Meyers, El Dorado County, California

Road Safety Audit

FINAL REPORT April 2016

Figure 13: N. Upper Truckee Rd (Aerial Image Source: Google Earth)

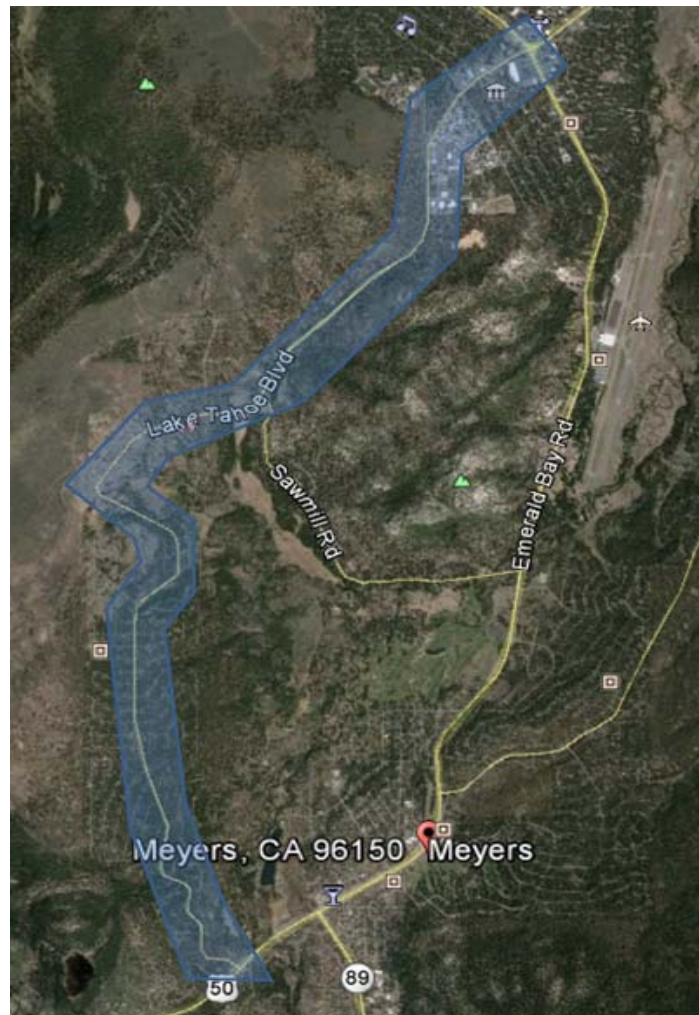
N. Upper Truckee Rd is a local neighborhood road that connects to Lake Tahoe Blvd and is a parallel route to US 50 into South Lake Tahoe, as shown in Figure 13. There are approximately 2,000 residential properties along N. Upper Truckee Rd which generates a high volume of local traffic daily. The 2014 AADT for N. Upper Truckee Rd was approximately 5,750 vehicles per day¹⁷. During peak periods this route has become a “bypass” for long traffic delays on US 50 through Meyers to leave Tahoe. Anecdotally, it is also thought to be used as a bypass of chain control during inclement weather events. It is also speculated that smart map technologies are showing this as an optional route, which results in higher than normal traffic volumes for this facility. During peak periods the traffic on this roadway likely exceeds its capacity as noted anecdotally by CHP, and local residents.

N. Upper Truckee Rd also accommodates a Class II bike lane. In both the 2010 El Dorado County traffic study and the 2016 TRPA/TMPO *Active Transportation Plan* the intersection with US 50 is designated as a top priority intersection for improvements. This intersection intersects US 50 on approximately a 6% grade, with a wide cross section. Drivers on US 50 tend to have high speeds (>40mph) on the downgrade and the N. Upper Truckee intersection may have limited sight distance during some seasons (i.e. trees, snow banks). No turn lanes are provided on N Upper Truckee Rd.

- Consider installation of **speed feedback signs** and lighting on the downgrade of EB US 50 and an **intersection ahead warning sign** possibly with the supplemental street name sign. See Figure 14 for examples.

- Consider **intersection design improvements** for safety and operations (i.e. turn lanes, checking sight distance/triangles seasonally)
- Consider static **signage** to discourage bypassing chain control or designation as a local road, “no through traffic/local traffic only”

Figure 20: Concept drawing of roundabout (Source:Caltrans PSR, 2015)

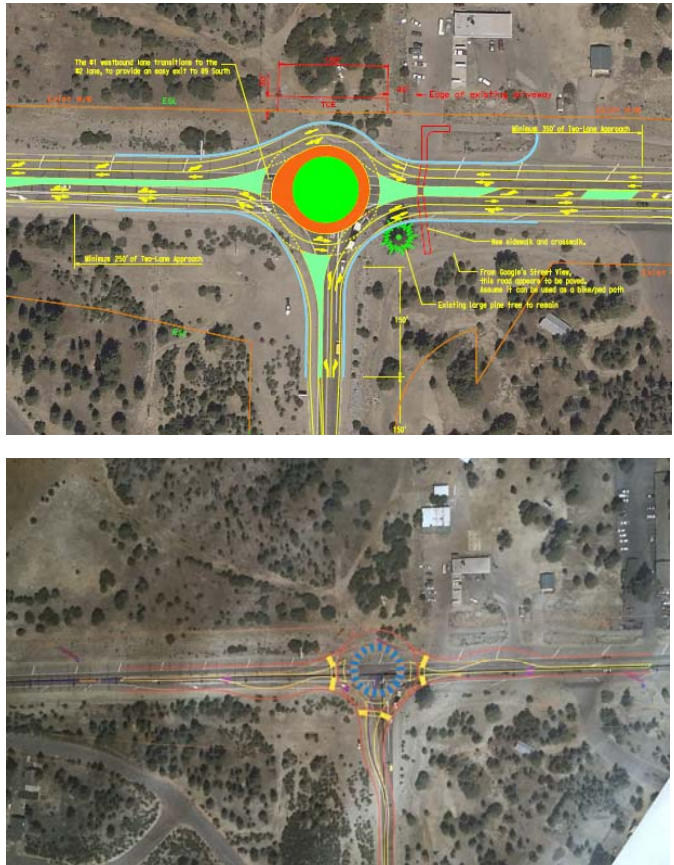
Both Caltrans and CHP noted that this intersection is the site of a number of vehicle crashes. Of particular note are rear-end crashes between vehicles that are turning from NB SR 89 to EB US 50. After stopping at the STOP sign on SR 89, vehicles enter the acceleration lane on US 50. However, the traffic volumes on US 50 often prevents the vehicle from SR 89 from merging onto US 50, which forces the merging vehicle to slow or stop in the acceleration lane. Drivers in the following vehicle may not see the vehicle in front is stopped, and the crash occurs. The CHP also noted a number of vehicles either run the STOP sign on SR 89 and proceed across US 50, or slide through the STOP sign and across US 50. A 1.2% grade leads SR 89 into the US 50 intersection.

- Consider **maintenance project to restripe** this area to **eliminate the acceleration lane** from SR 89 to US 50 and **restripe the bike lane markings** on US 50 to be consistent and use of state of the practice for bike lane markings though and approaching intersections.

- Agency collaboration on **rightsizing roundabout improvement** consistent with Caltrans Intersection Control Evaluation (ICE) directive and state of the practice roundabout design guidance and operational tools.

- Consider reconstruction of US 50/SR 89 to **include gateway features and create a transition/traffic calming presence** i.e. lower posted speed²⁶ through the remainder of Meyers (increase posted speed, as appropriate, after Pioneer Trail intersection).

- Consider possible **new configurations for chain up area** as a part of roundabout design so project does not preclude future changes to the chain up area (i.e. separation between travel lanes and chain up area, additional chain up area).

Figure 25: Comparison of a commercial driveway designed with and without emphasis on sidewalk (Source: FHWA)

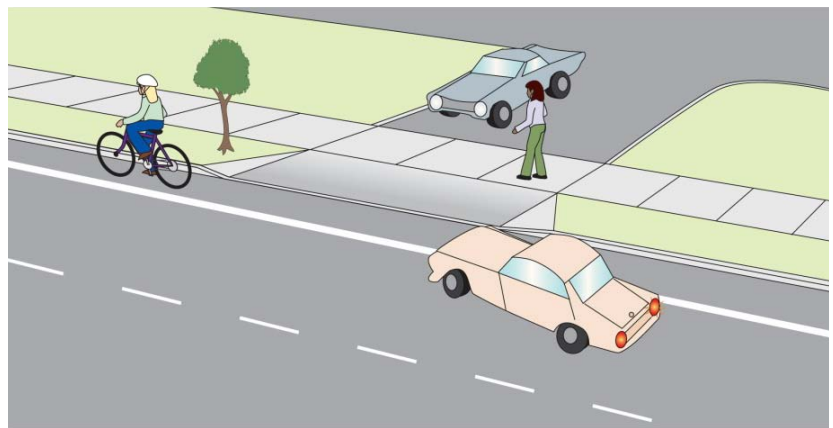
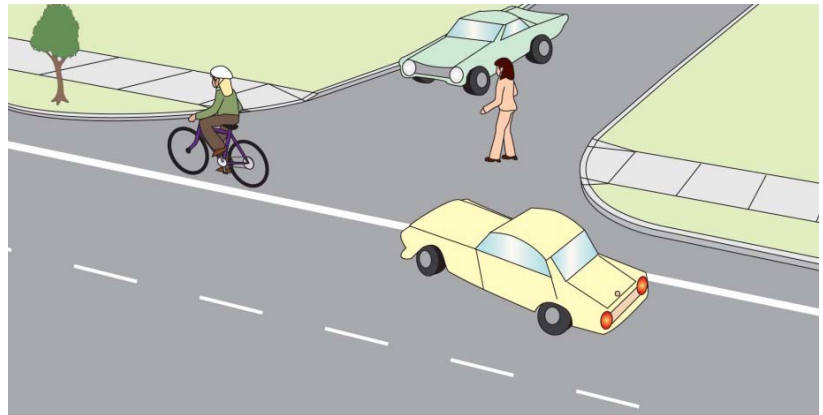
In this 1,500ft stretch of the study area, there are 11 access points (driveways) with almost all of those being within 700ft of the Santa Fe St/Apache Ave intersection. This includes one lane in each direction on US 50, a two-way-left-hand-turn-lane (TWLTL) and a Class I and II bikeway. Between the golf course parking lot and just west of Pioneer Trail the right of way through Meyers is its narrowest.

- Re-design²⁸ driveways to allow the Class I pathway to be contiguous through the driveways, reducing effect that the driveway looks and operates like an intersection, as shown in Figure 25.

Figure 26: Pioneer Trail Intersection (Source: Isebrands)

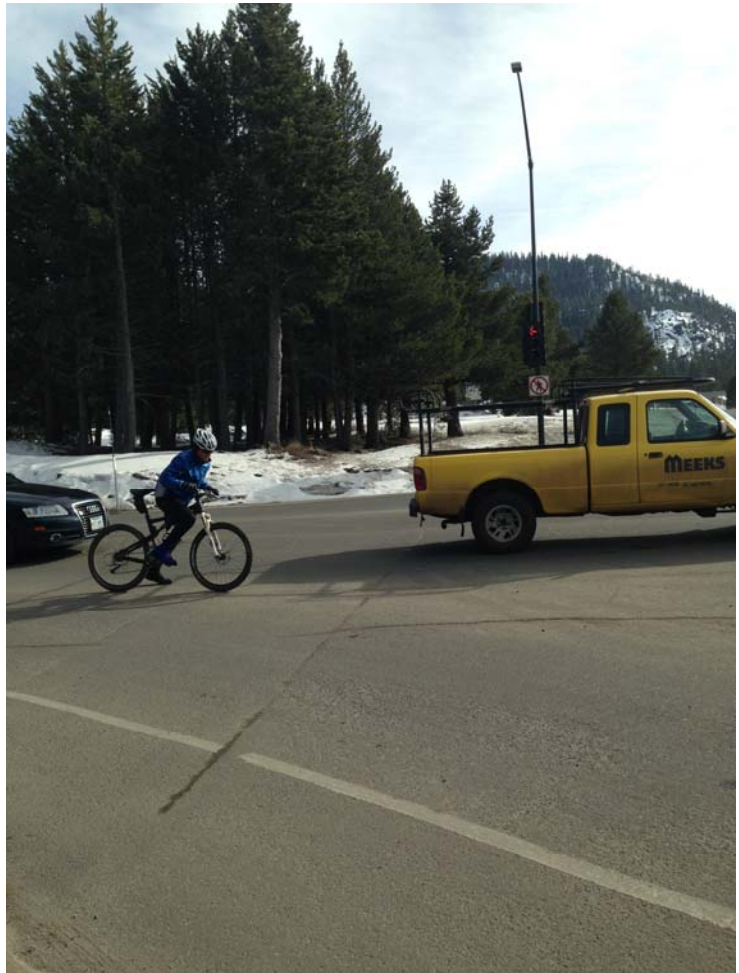
The Pioneer Trail intersection is the northern gateway to Meyers from South Lake Tahoe. It is the only signalized intersection in the study area. Drivers are required to reduce their 55 mph speed to a 40 mph headed into Meyers in this area. The AADT of Pioneer Trail is approximately 6,335 vehicles per day. According to CHP this is the highest crash location within the study area. This intersection is a choke point during the peak periods. Right turning vehicles from NB US 50 to Pioneer Trail are given priority for intersection efficiency (right green arrow). This right turn tends to be a fast movement. During the winter months this area can be icy (cross slope, drainage issues and lack of sun/freeze-thaw) and contributes to crashes. A number of the crashes occur when vehicles on EB US 50 turn right onto EB Pioneer Trail at an unsafe speed and then slide into the WB side of Pioneer Trail. Intersection and stopping sight distance/triangles at the intersection may be affected by trees, poles, signal cabinet and signs.

Pedestrian and bicycle facilities are disjointed and lack connectivity at this intersection. Pedestrians are only allowed to cross US 50 in the crosswalk on the north side of the intersection and that crossing does not connect to another pedestrian facility. All other pedestrian movements are prohibited. The Class I bicycle facility parallel to US 50 does not connect to the Class II facility or the Class I pathway east of US 50.

- Consider providing **full access for pedestrians and bicyclists** including crosswalks and refuge islands.
- Provide a crosswalk across Pioneer Trail to **connect the crosswalk to the Class I bikeway**.
- Consider **alternative signal timings** (adaptive signals) based on demand - daily and seasonally.
- Examine feasibility of modifying the low area on the right turn to **improve drainage**. If reconstruction is not an option, high-friction surface treatment (HFST) may improve the area at a lower cost and in a shorter time frame.
- Consideration could be given to this intersection serving as a **gateway to Meyers** with features that would encourage slower speeds through Meyers.
- Long term consideration for a roundabout.
